ADDENDUM NO. FOUR

PROJECT: Johnson County Recycling Center

PROJECT NUMBER: 23122

DATE OF ADDENDUM: June 5, 2024

TOPOGRAPHICAL SURVEY

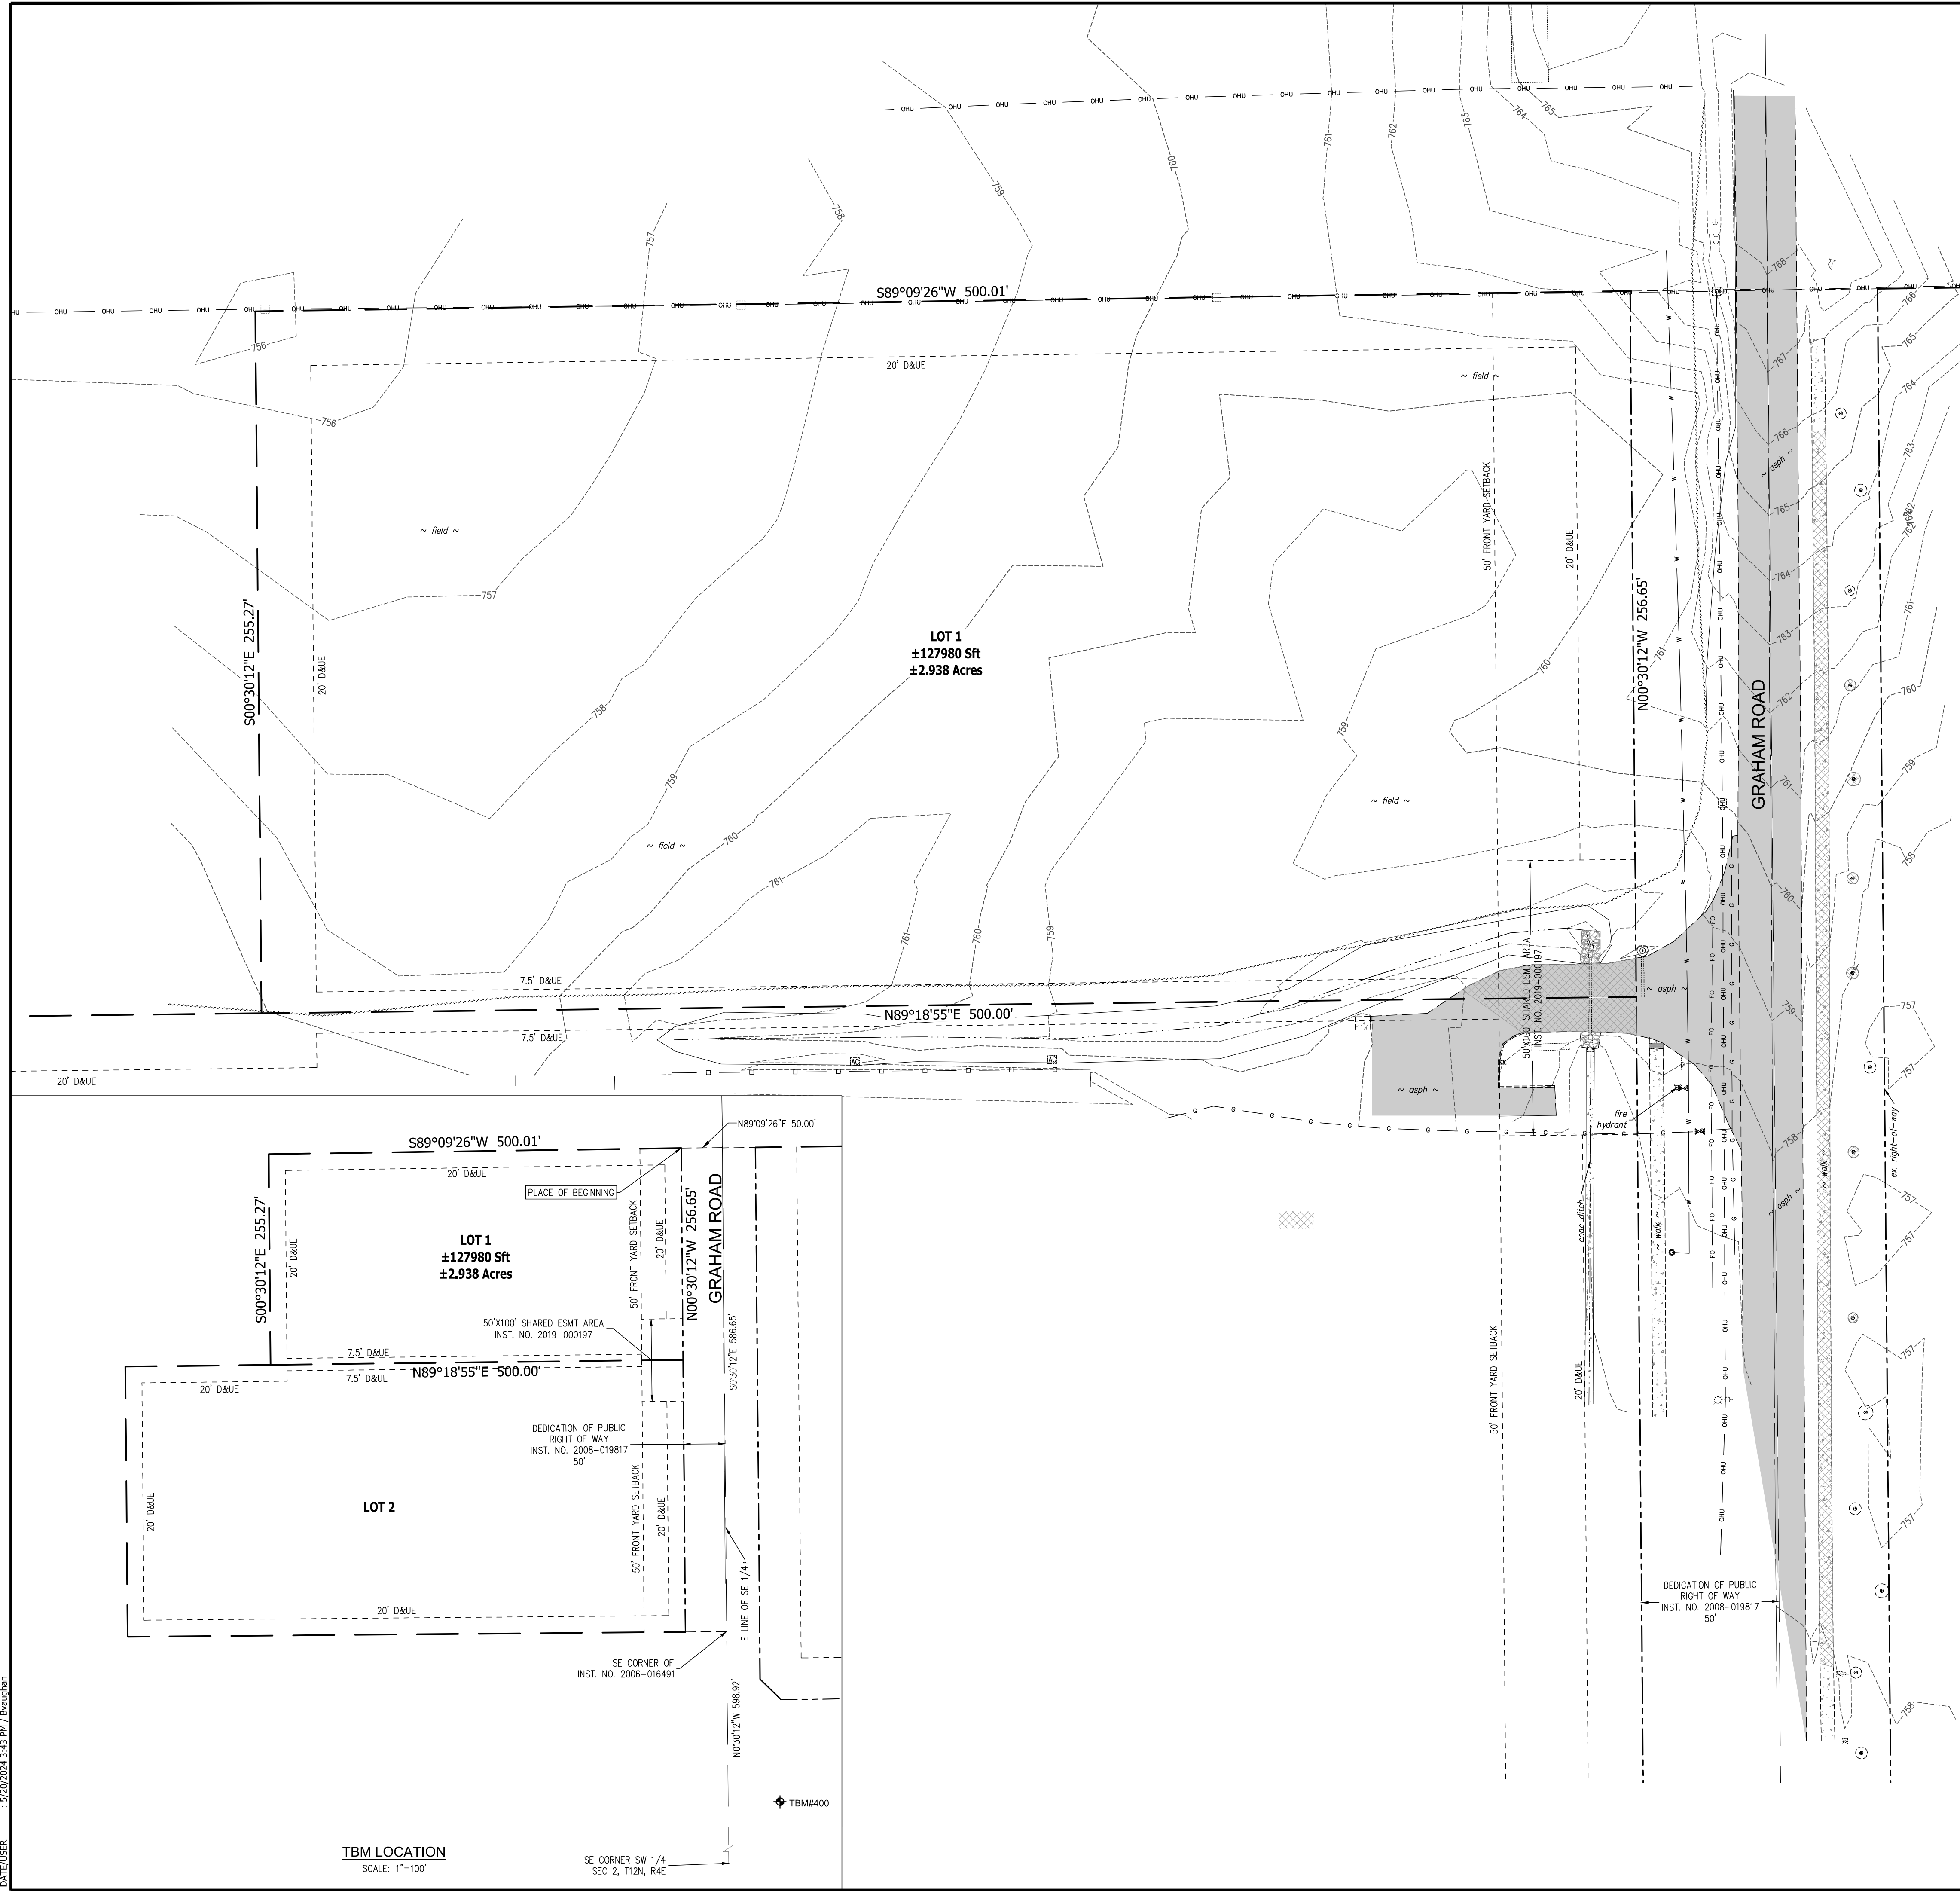
- Sheet 100
 - o Updated the INDOT Specs to be dated 2024
- Sheet 200
 - o Added Note 3 to the Topographical Notes regarding demolition of the existing drive and access to the adjacent business

SITE DIMENSION LEGEND

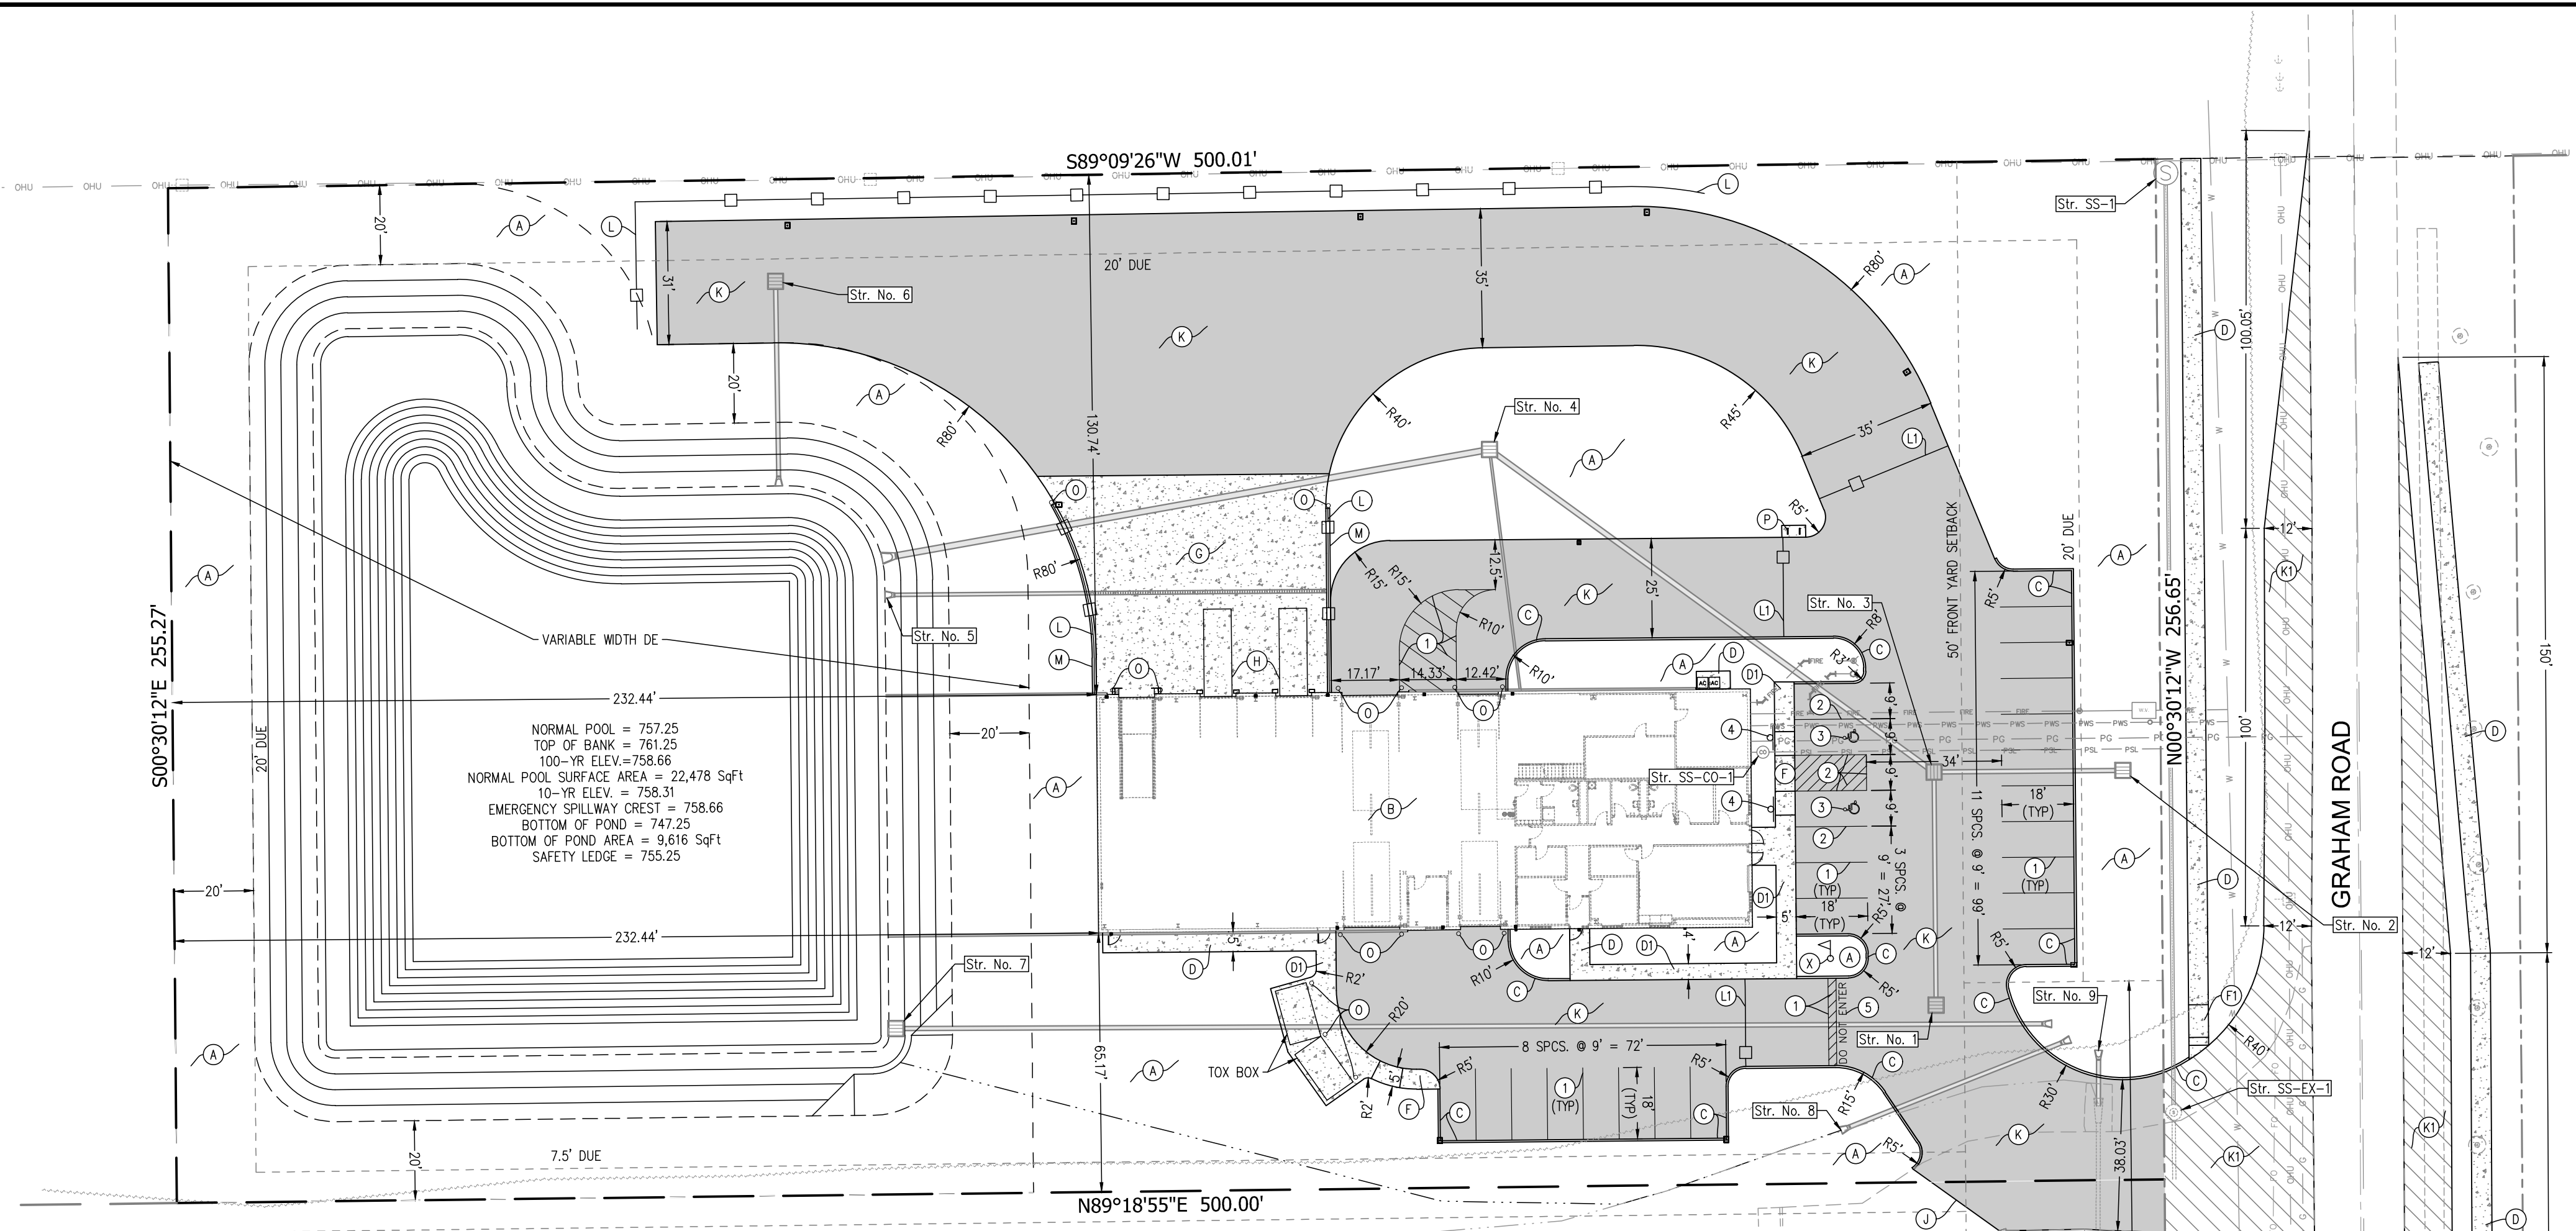
- Sheet 300
 - o Changed the striping and added words at the exit aisle from the drive through; added item 5 to the Site Dimension Legend
 - o Added striping between the two entrance bays to the drive through

- o Reduced sidewalk width along the edge of pavement of the exit drive aisle to 4 feet wide
 - o Added space for a second Tox Box south of the building and modified the sidewalk accordingly

- o Added small concrete pad for mechanical equipment north of the building
 - o Added Note 9 regarding drive construction and adjacent business access

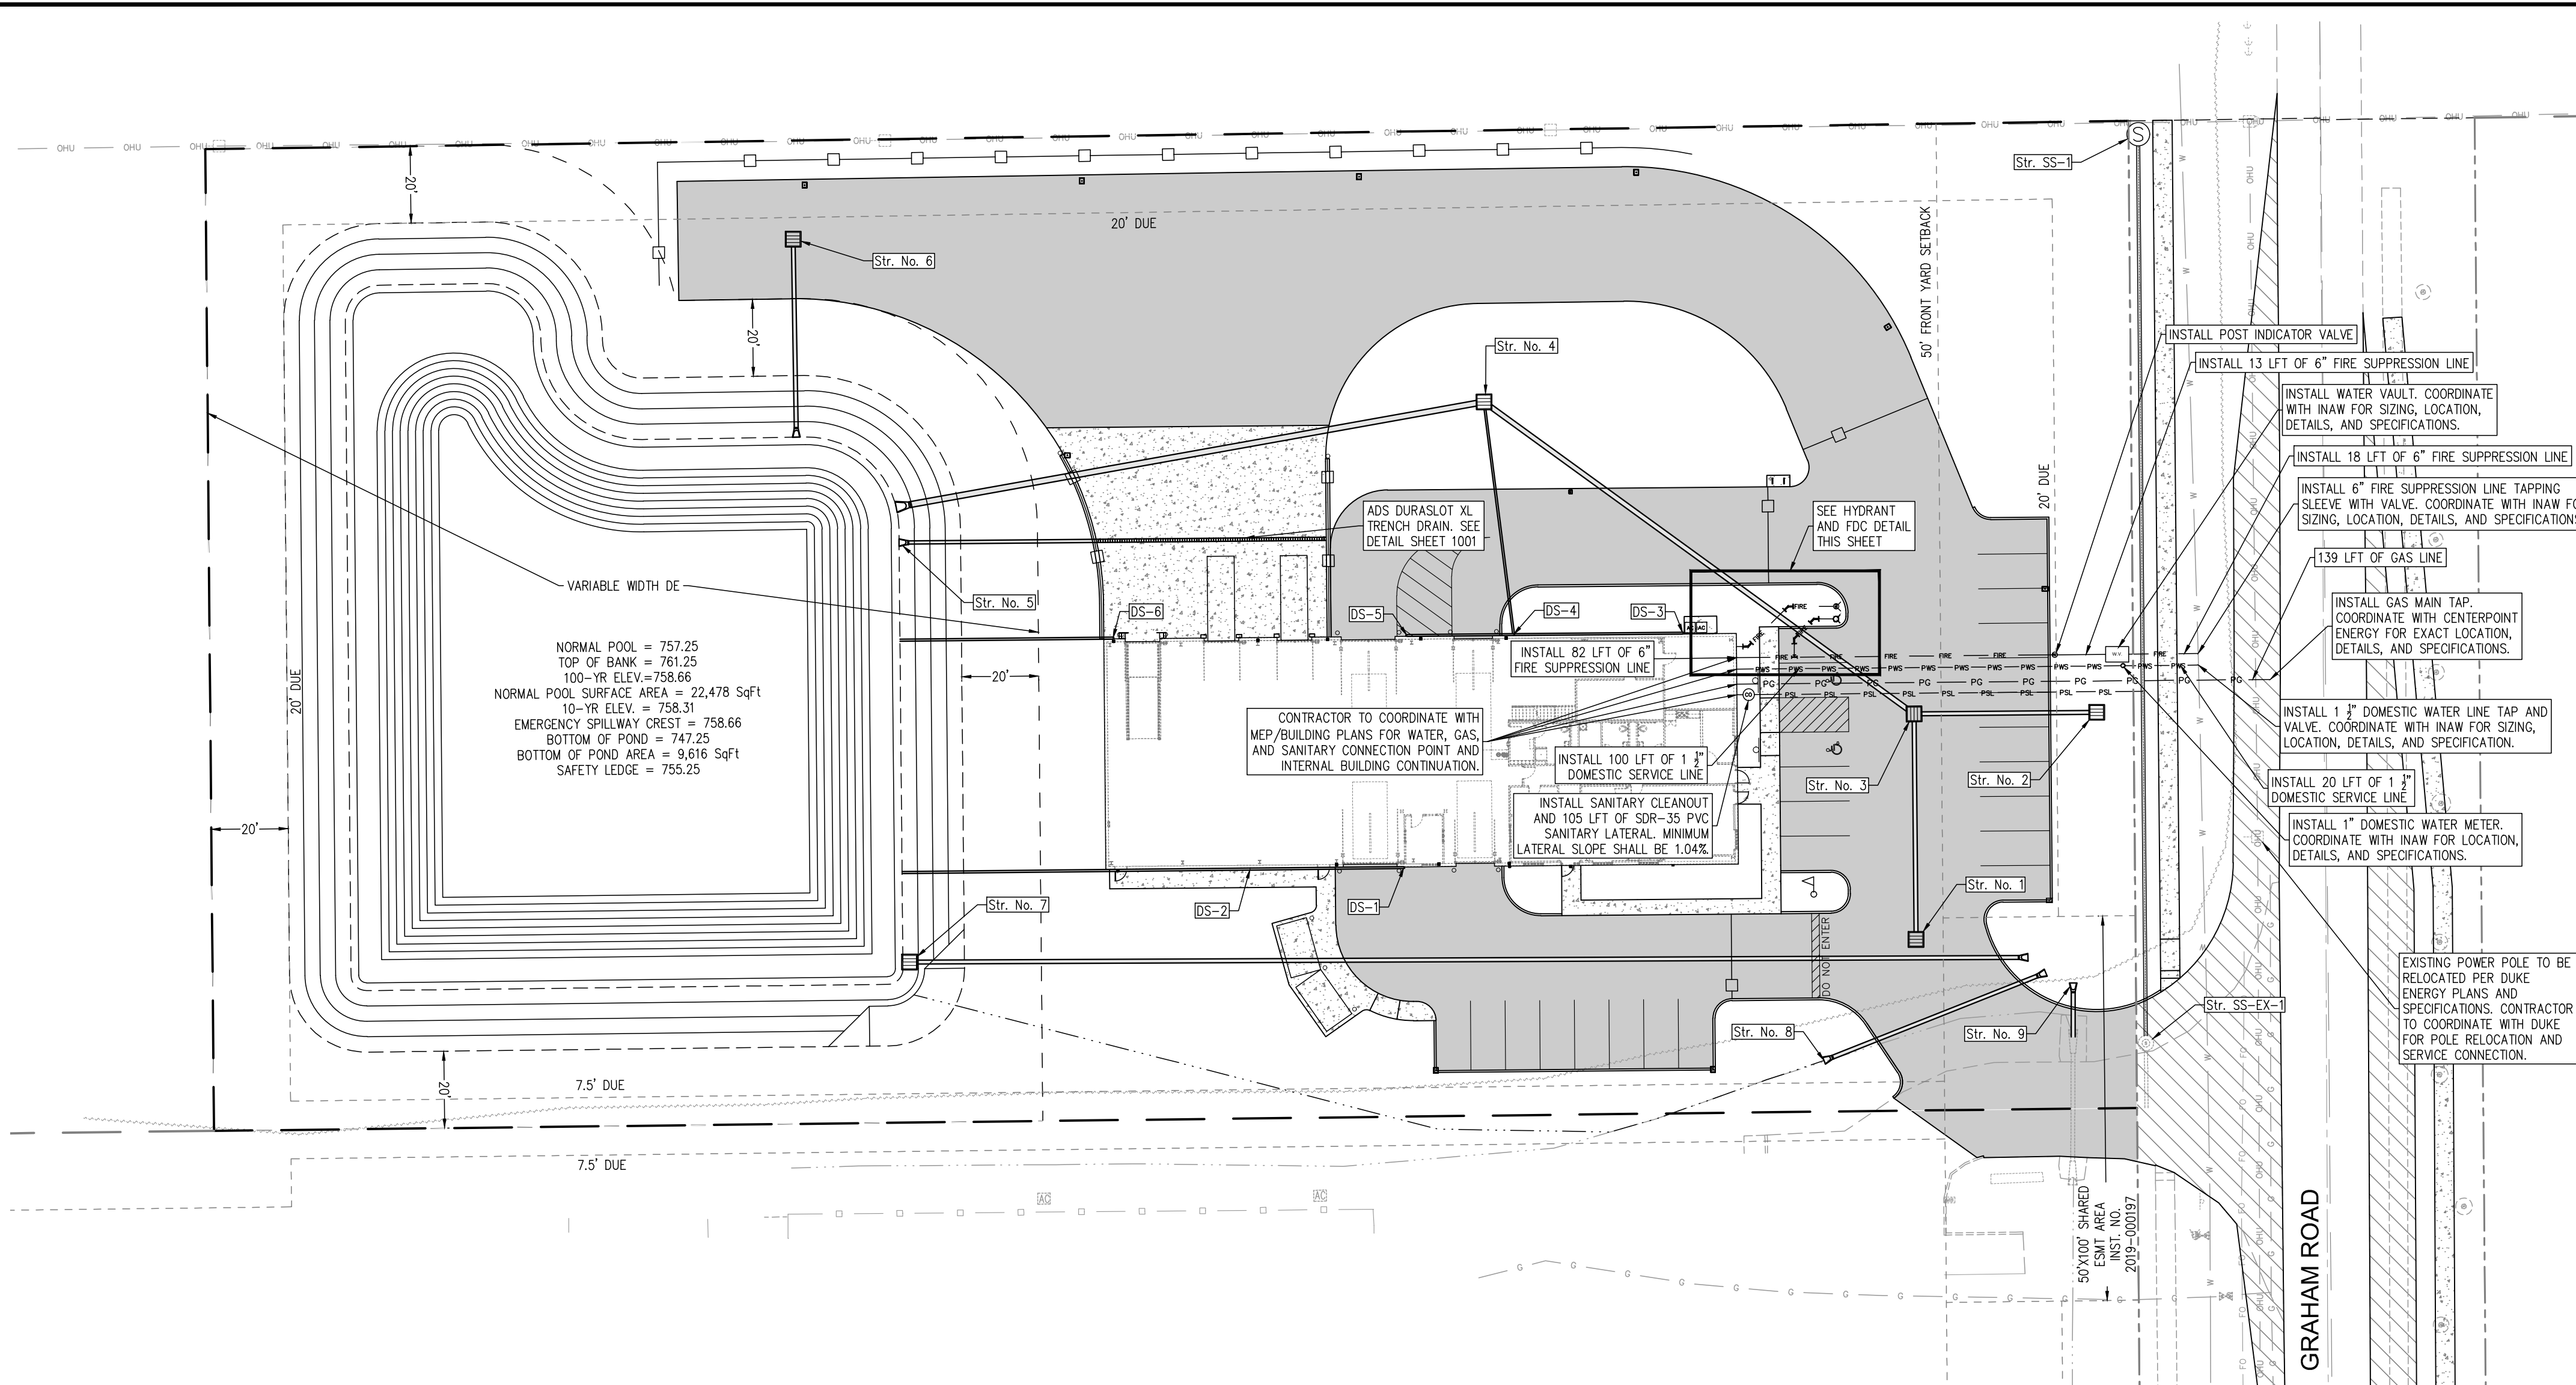
- Sheet 400
 - o Adjusted downspouts on the north side of the building. Downspout at the west end to be collected and piped to pond. Remaining downspouts on north to be joined and piped to Str. No. 4. Modified Storm Downspout Data Table accordingly.

- o Modified pipe type and size for Str. No. 5 leaving the ADS Duraslot XL Trench Drain. Pipe is now 10" HDPE pipe
 - o Added Note 14 to the Utility Notes
